**General Bid Bulletin No. 5**  
**28 April 2021**

**IFB No. 21-031-4**

**THE MALOLOS-CLARK RAILWAY PROJECT AND  
THE NORTH SOUTH RAILWAY PROJECT-SOUTH LINE (COMMUTER)  
PACKAGE CP NS-03: ROLLING STOCK-LIMITED EXPRESS TRAINSETS**

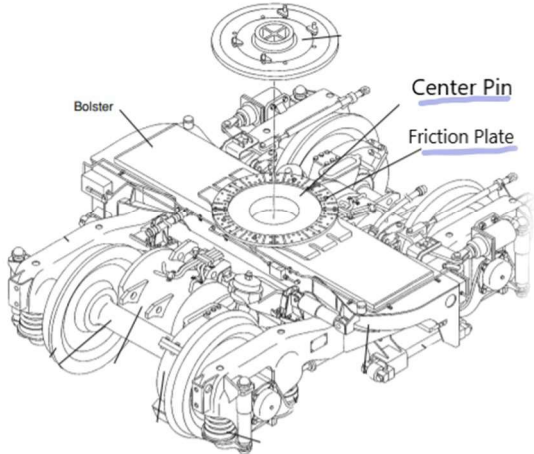
2	Volume II Part 2 -Employer's Requirements Section V1. Technical Requirements ERT-6 1.6.1.2	Typical vehicle configuration is shown in Appendix B.		Appendix B - Typical Limited Express Train Layout and B1- Door Position and Door Pitches are for the bidder reference and information only.
